Prepared for
Star Entertainment Group

Date
6 November 2018

Addendum response to submissions: Visual Impact

Star Modification 13

1 - Submission 279707, 4A / 4 Distillery Drive

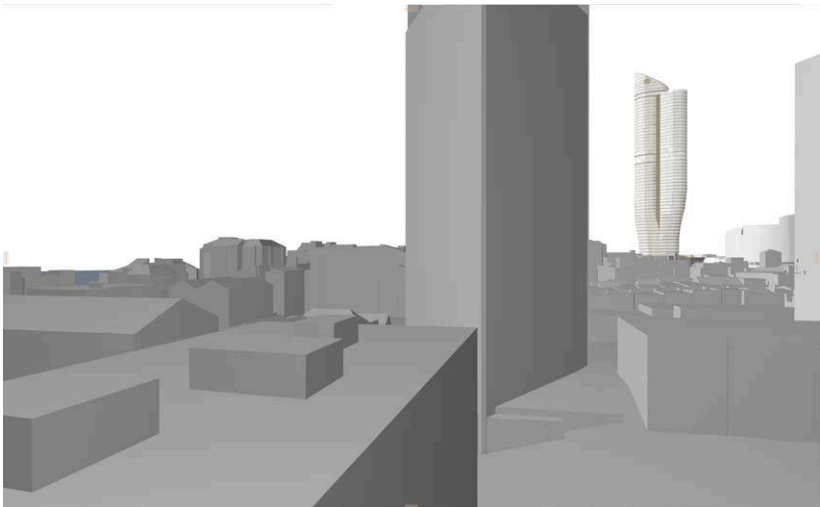
“27. While private views and overshadowing are by no means a determinative reason for refusal, the proposal will also have an adverse impact on the views and solar access to my apartment among others in Jackson's Landing. These impacts have not been assessed.

29. The attached photo also demonstrates that the proposal will destroy the current city skyline views from -my living room window like an outsized monster-looming between the-towers on Distillery Hill. The view impact assessment has not addressed any of the impacts on views from Stonecutters or Sugar Dock. There is an assessment from level 17 of Quarry {8 Distillery Drive} {See Architectus View Impact Assessment p128-129; but while there is an impact in scale from that building there is self-evidently little impact on views as it has expansive east facing city views from North Sydney to Central. In that context the single tower proposed will not have much Impact, but from apartments at Stonecutters and Sugar Dock that depend on a corridor of view between The Distillery and Quarry, the impact will be dramatic.”

Within the Visual Impact Assessment submitted with the application, detailed view analysis was not undertaken for this building however it is considered with reference to views from other buildings in a similar location (21 Cadigal Avenue and 8 Distillery Drive) and it is noted that buildings in this vicinity will receive “a moderate impact from the

A supplementary view has been produced from this location as part of this response to submissions and is included in Appendix A of this document. In summary, the proposal forms a new element in the skyline, sitting between the scale of the city skyline and the scale of nearby buildings ('The Distillery' and 'The Quarry') which form a larger frame for the view. The photograph taken is also understood based on the plans to be taken in an oblique direction from the balcony. Most of the front facing view from the living rooms for apartments in this block faces further north, away from the subject site. The proposal's impact on the view would be moderate which is consistent with the assessment provided in the Visual Impact Assessment submitted.

2 - Submission 280638

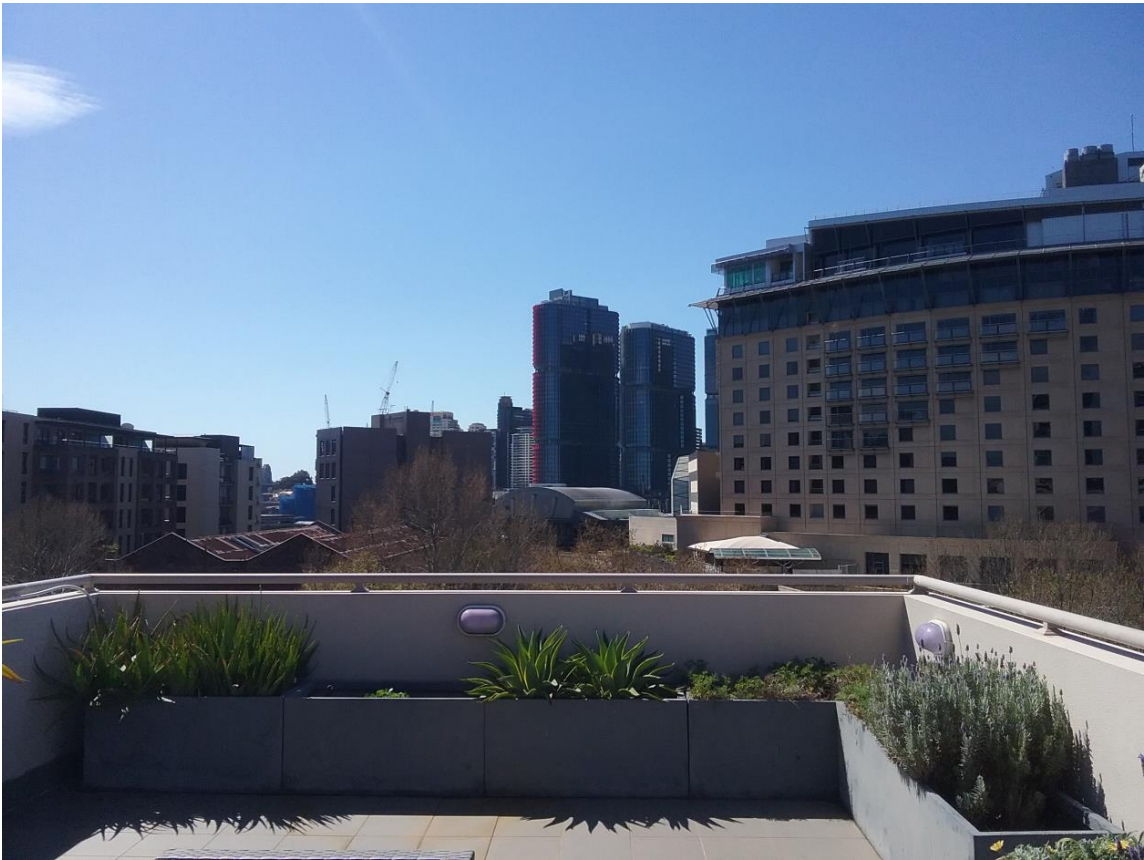
"Towers of such height in such location ought not be permitted, for having too severe an effect on our local residential and relatively low rise amenity. As I write this I am looking out towards the direction such tower will be. The Barangaroo towers tops seen in the relatively same direction but at a distance are visually dominant already. A 237m tower so much closer in distance to us will detrimentally change both the outlook but also the character of the visual neighbourhood"

A supplementary view has been produced from each of these locations as part of this response to submissions and is included in Appendix A of this document for consideration.

Neither of these locations enjoy elements of the highest significance based on the planning framework and planning principles (such as water views or views of iconic elements such as the Sydney Opera House) however they do enjoy an element of sky and skyline views. The proposal will be prominent in views due to its size however primarily obstructs areas of the sky in both views. It also obstructs an area of other buildings in the Barangaroo area for submission 280515.

3 - Submission 280518

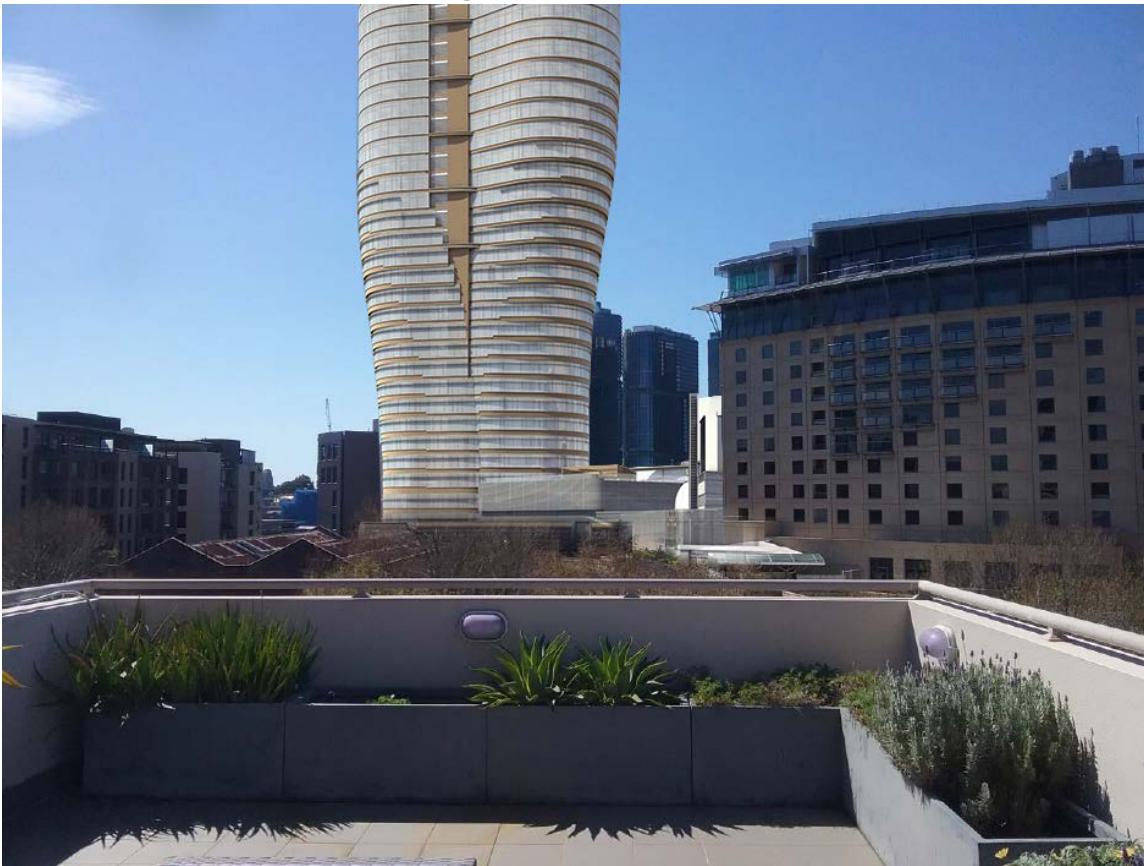
"I will lose significant views and light if this development proceeds,"

4 - Submission 284218, 14 Pyrmont Street

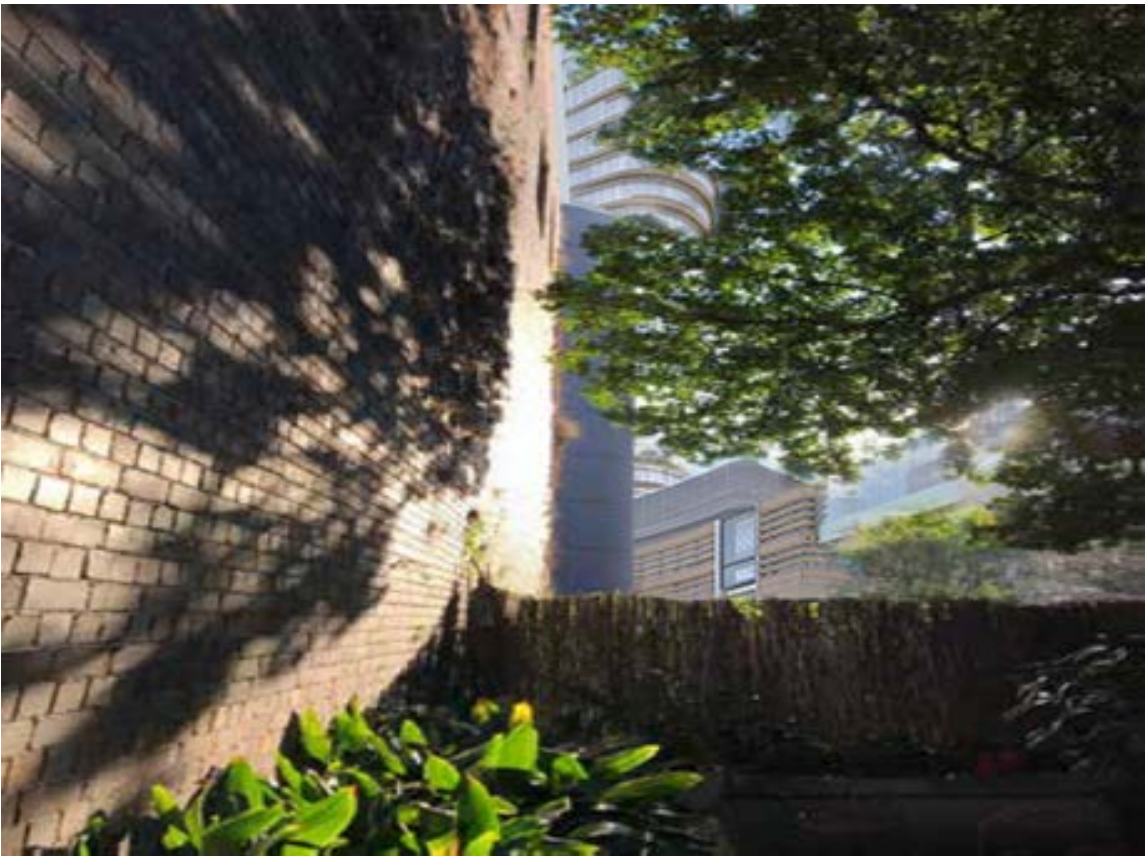
"This massive 237m tower has extremely detrimental impacts on sunlight and views throughout the precinct!"

A supplementary view has been produced from each of these properties as part of this response to submissions. These are included in Appendix A of this document.

The existing view from these terraces is across a public street to the existing Star building. These views do not include important elements (e.g. water views or views of iconic elements) which are enjoyed by other buildings assessed and thus its importance is considered low. There is a substantial change proposed to this view with the proposal forming a major part of the view and creating a new scale close to the site, obstructing a significant portion of the visible sky. This may be summarized as being a moderate impact to this view of low importance. It is considered to be reasonable and acceptable in line with the overall assessment of the proposal presented in the submitted Visual Impact Assessment.

5 - Submission 281102, 16 Pyrmont Street

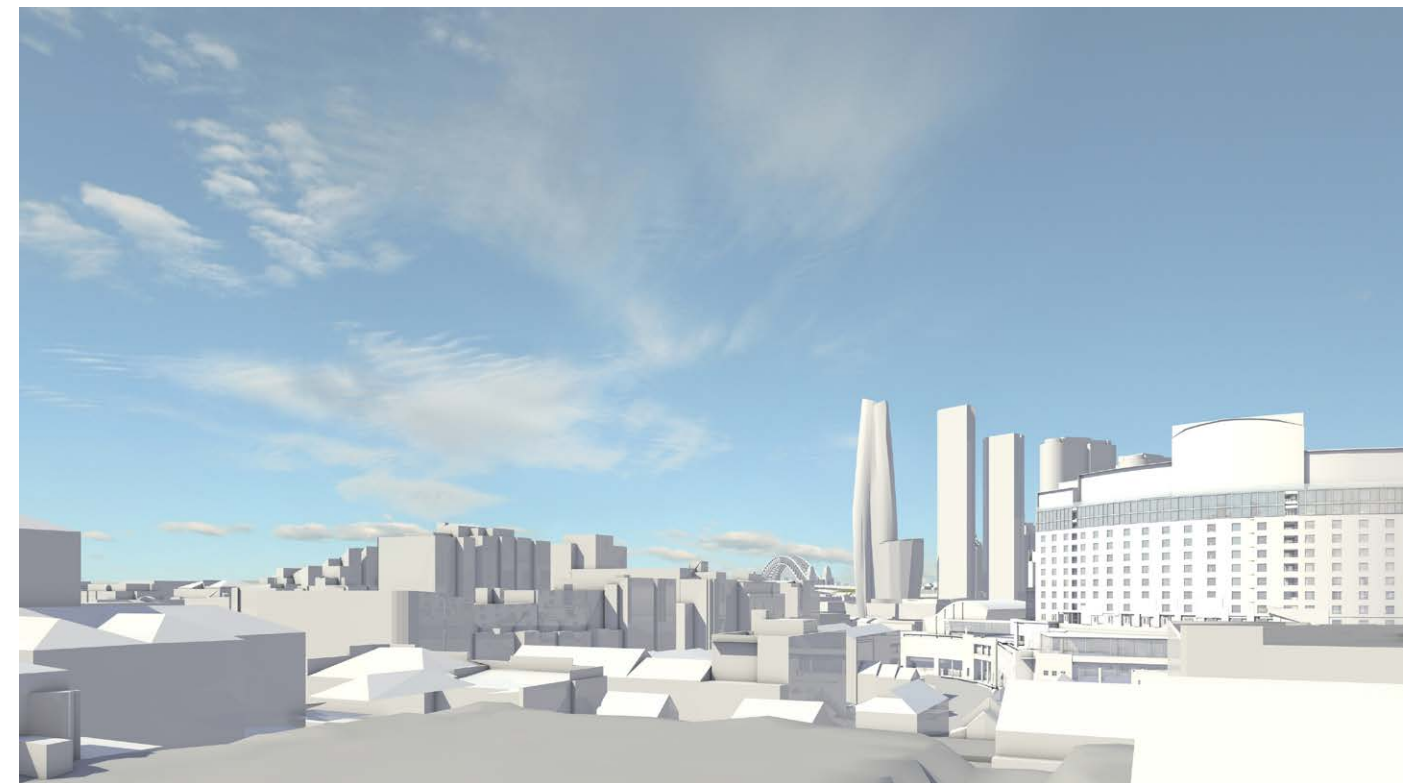
"Note all the photographic assessments, thus impact assessments in the Mod 13 documentation are viewed perspectives from the footpath in front of St Bede's Church or viewed perspectives from the forecourt of the SELS building or viewed perspectives from apartments on levels above ground, not terrace homes on ground with backyards None of the proposed development views and photographic assessments are actually from the 3 remaining terraces, thus the immediate and future views in all photographic assessments / regarding private views impacted and considered under the planning framework are skewed and inaccurate as far as actual views immediate and future from the 3 terraces homes"

"The extent of change and the negative visual impact with both proposals height and bulk of glazing"

Residence 752

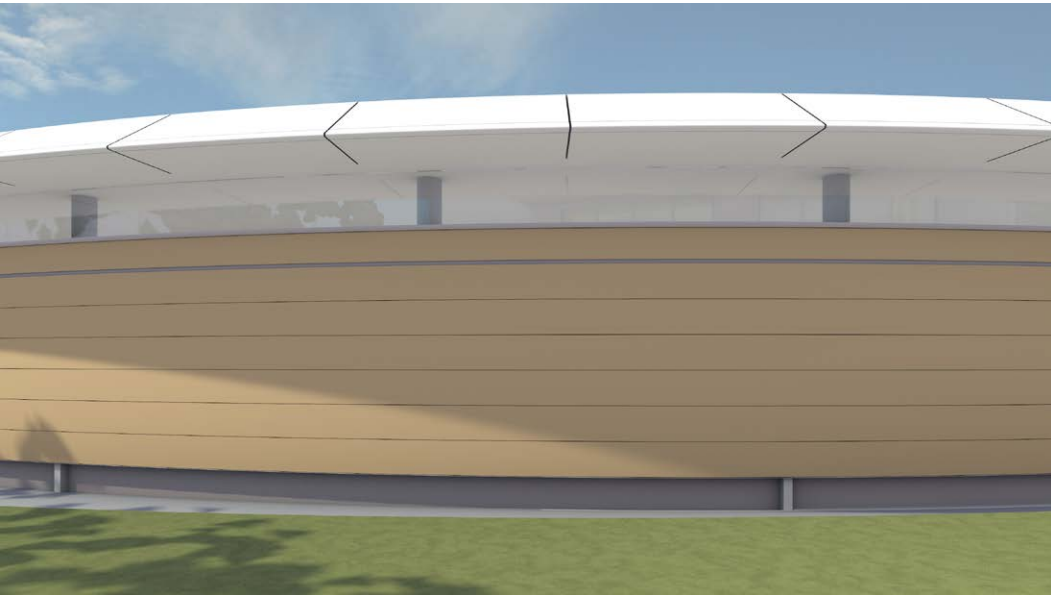
“13. Provide an assessment of the impact on private views from the serviced apartments (not owned by The Star) within the Astral Residences tower.”.

- Residence 752 is on the current rooftop level. The proposal's new facilities (on the existing rooftop) will obstruct their horizon and city skyline views as well as small areas of water. As shown in the submitted Visual Impact Assessment for the proposal, the part of the proposal that obstructs views is within the LEP height control. On this basis according to the planning principles there is a reasonable expectation for development here.
- Residences 851 and 852 which are jointly owned and the subject of submission 281100 (see below) would have horizon, water and the lower portion of city skyline views obstructed by the proposal, primarily the 'ribbon' element.

Residence 851

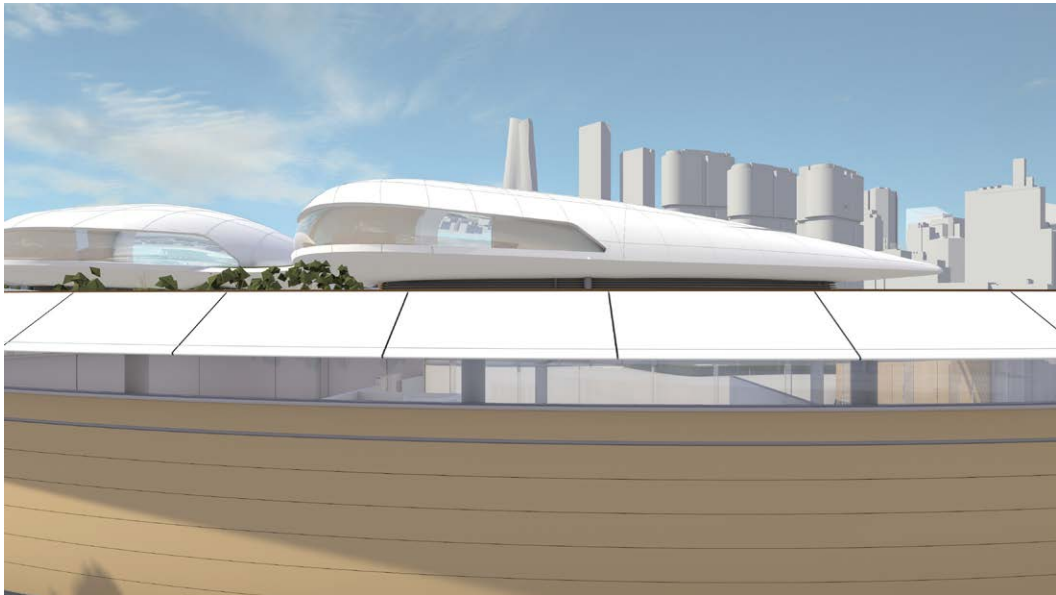
“- The current views enjoyed by residents and occupants of the Astral Residences are highly valued. The proposed ribbons are noted as architectural features connecting new uses to each other. However, it appears that these architectural features will cause detrimental by causing a disruption of these views

- *It is clear that the impact of the ribbon buildings, and to some extent the Level 5 Sky Terrace, will result in the impeding of primary, existing water views for our clients' units (and those units below). These views were assessed to be 'high importance' and 'moderate to high visual impact' in the VIA*

Two supplementary views have been produced to show the proposal's visual impact on this property. They are included in Appendix A of this document. Further discussion of the proposal's impact on the Astral Residences, including these apartments, is included above – see 2.3 'Department of Planning – Schedule of Key Issues' above.
